SAVE THE PUTNAM TRAIL (SPT) Statement on the New Paved Design for the Putnam Trail and the SWPPP Exclusion Claimed by DPR

Slides used by Parks Dept engineer in a presentation of the new design to the community board (Dec 2015)
 Notes: Margarita Eremeyev

Layout: Sections 7-8

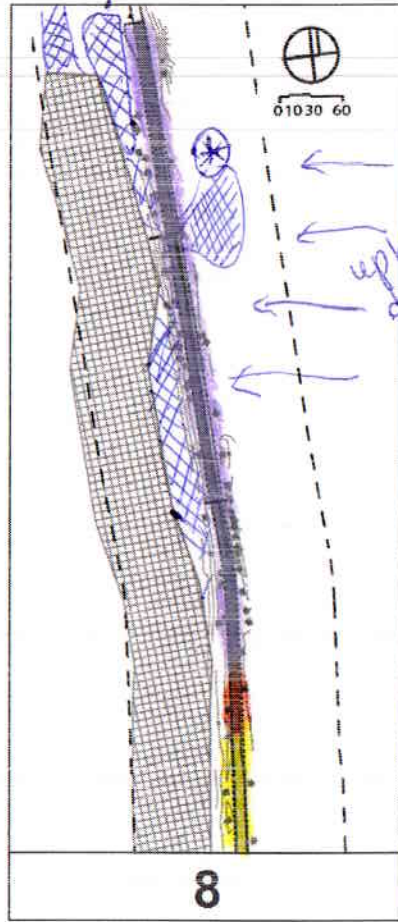
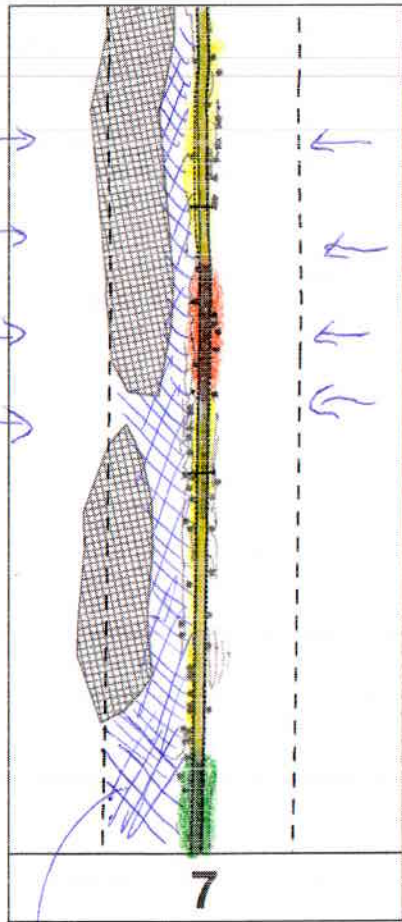
→ vernal pools not captured by wetland mapping

watershed draining to trail

uphill drainage to trail

→ seasonal pools - part of wetland - CANNOT BE PART OF STAGING OR CLEARING AREA!
 ⊗ area of annual overflow from Canton Woods water supply
